ALTERATION TO A HISTORIC PROPERTY STAFF REPORT

Site: 381 Summer Street, Rosebud Diner (c. 1940)

Case: HPC 2014.018

Date of Application: March 25, 2014 Legal Notice: Revise ADA access

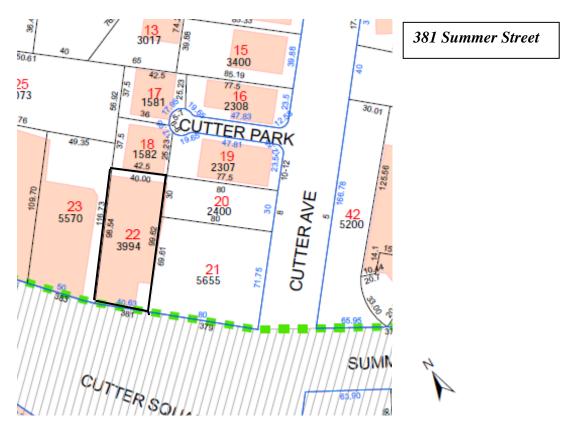
4. The original layout and materials of the walks, steps and paved areas should be maintained if significant grade changes constitute an important feature of the structure or site. Consideration will be given to alterations if it can be shown that improved site circulation is necessary and that the alterations will accomplish this without altering the integrity of the structure.

There are no changes to the layout of the walkway to the rear building.
